Lindfield Learning Village Phase 2 and 3 – amended proposal

Ku-ring-gai Council submission

Figure 10: Walking routes

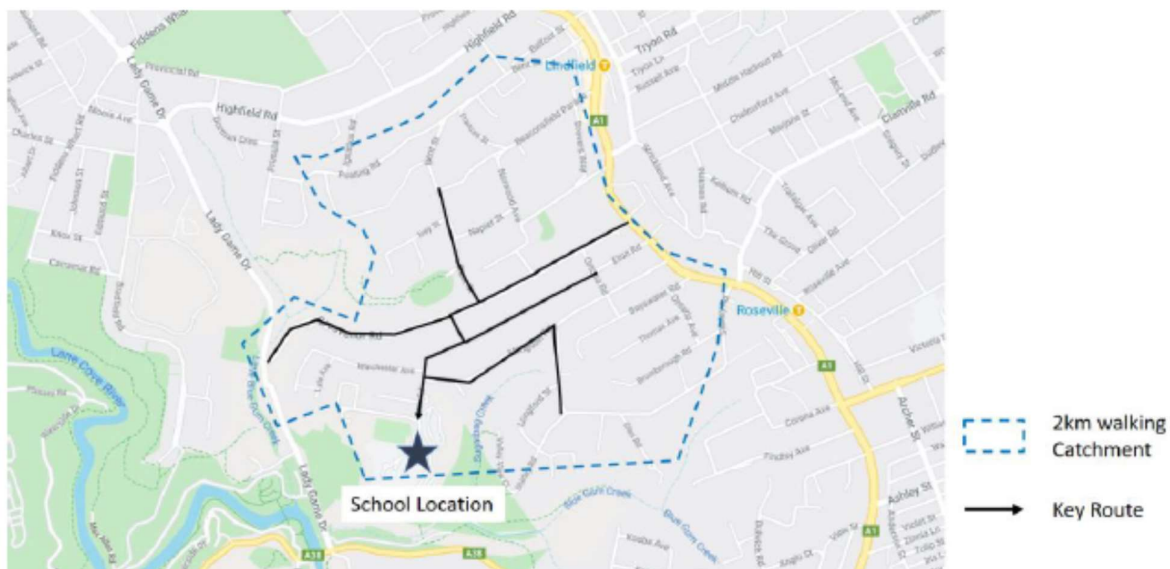
The walking catchment is heavily biased to the north of the school site, due to missing links to the south. However, there appears to be the potential to link to the southern part of the catchment –

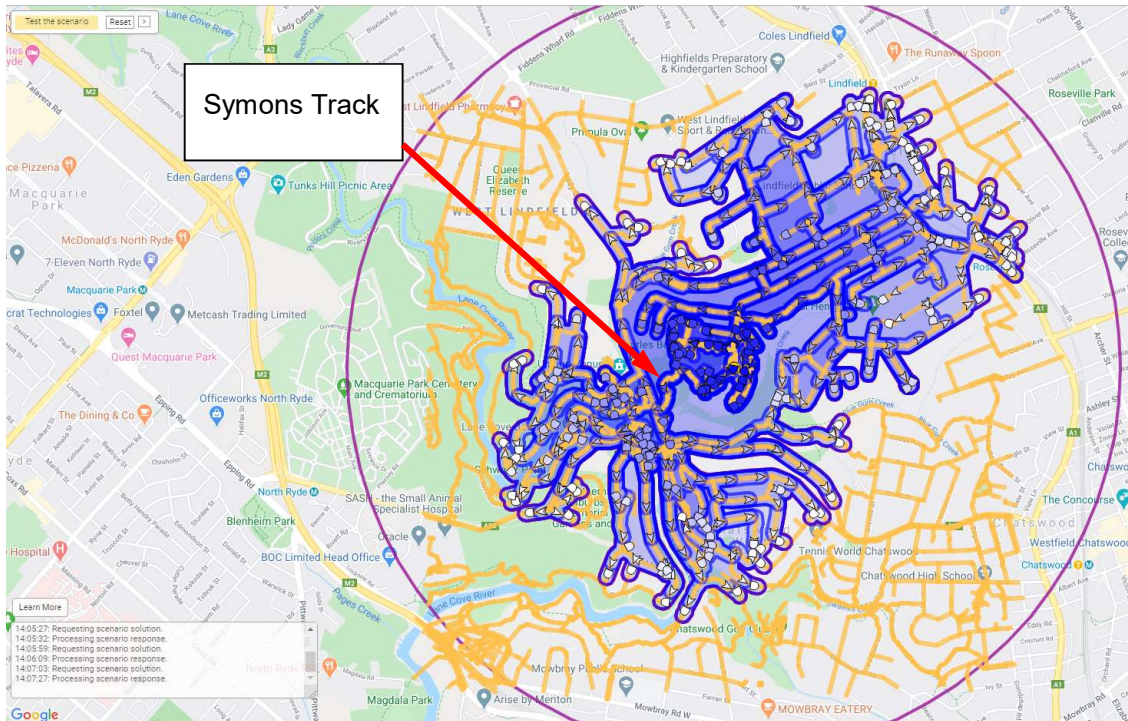
see plan below indicating the extent of the 2km walking catchment, using the Pedcatch tool (not considering gradients):

This tool identifies Symons Track as a key link from the school southerly to Lady Game Drive, which then provides walking connections to the southern parts of West Lindfield and to Chatswood West. As part of this assessment, there were no investigations carried out to assess the suitability of this track for students, although images on Google Maps indicate the presence of a formalised/established National Parks trail from Lady Game Drive leading to the Crimson Hill development (adjacent to the school):

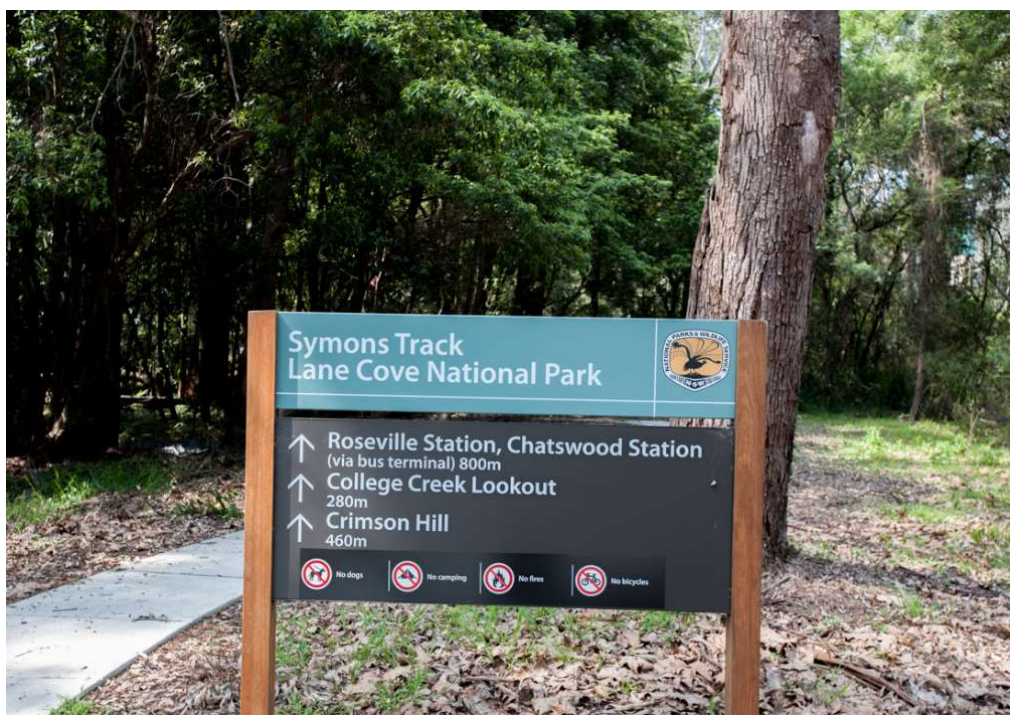
Investigations should be undertaken to assess the track's suitability, as upgrading it/incorporating it into the school's pedestrian access routes would potentially add a substantial area into the school's walking catchment.

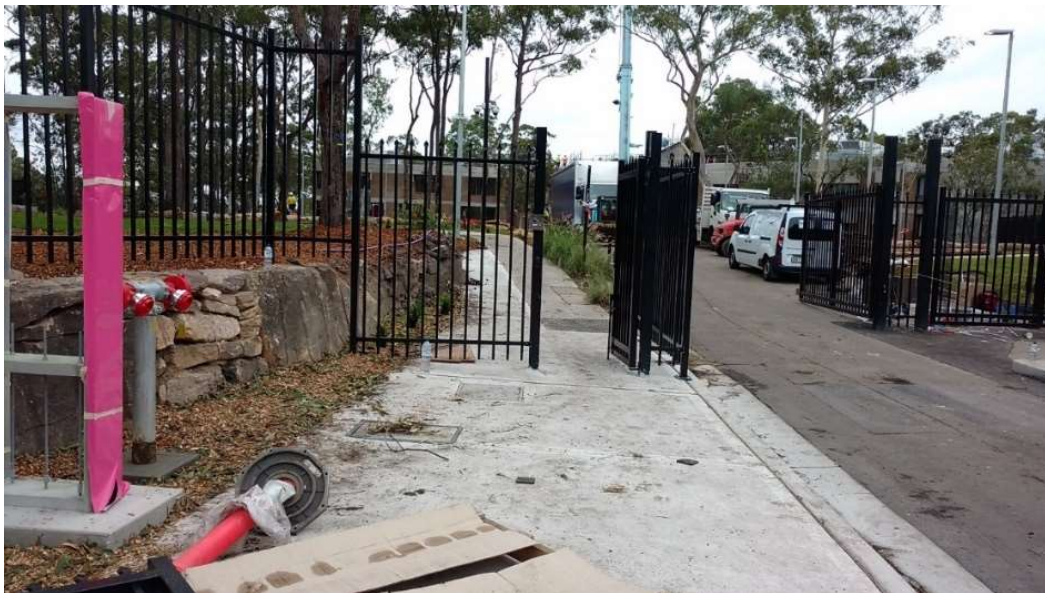
In Council's feedback to the Response to Submissions, it was identified that at the main school gate, the path is >2m side, but the gate opening in the perimeter fence is only half that (see image below), which would obstruct pedestrian and bicycle flow particularly in Phases 2 and 3.

It was suggested that this gate opening would need to be operable on both sides so as to accommodate the full width of the footpath. As there was no acknowledgement of this in the TRS, it is raised again here for attention.
